66319D-07

S E R V I C E N O T E

Agilent 66319D DC Power Supply

On faster computers, when programming over GPIB, a random error will occur.

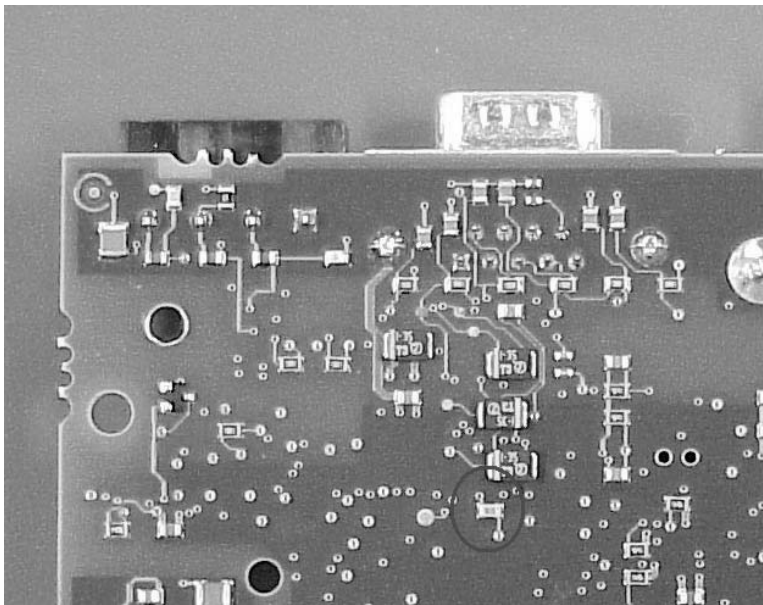
When programming a unit over GPIB, a random error -113 (“Undefined header”) will appear on the unit. This error can be read back via the front panel or over the GPIB bus.

Change resistor R1246 (see picture for location) from 511 Ohms to 100 Ohms (part number 0699-3058). This requires soldering a surface mount component and can be very difficult. This does not require re-calibration.

Replace the entire GPIB assembly (part number 5063-4841) with a newer one that has the 100 Ohm resistor. This will require the unit to be re-calibrated.
